7.1.3 MONASH BOULEVARDS UDF IMPLEMENTATION - AMENDMENT C172 - CONSIDERATION OF PANEL REPORT AND ADOPTION

Monash Planning Scheme Amendment C172mona The Monash Boulevards Urban Design Framework

Monash Planning Scheme Amendment C172mona

Figure 1 Subject land

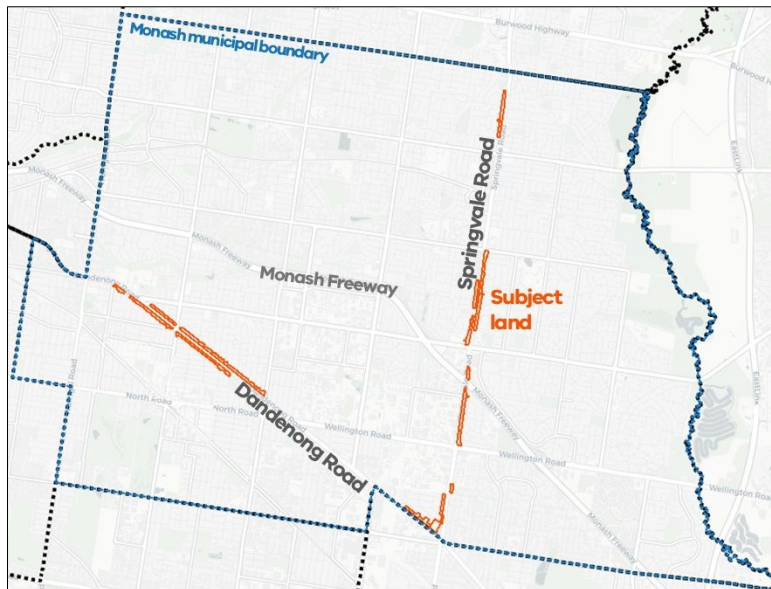
The Amendment applies to land shown within the orange outline in Figure 1.
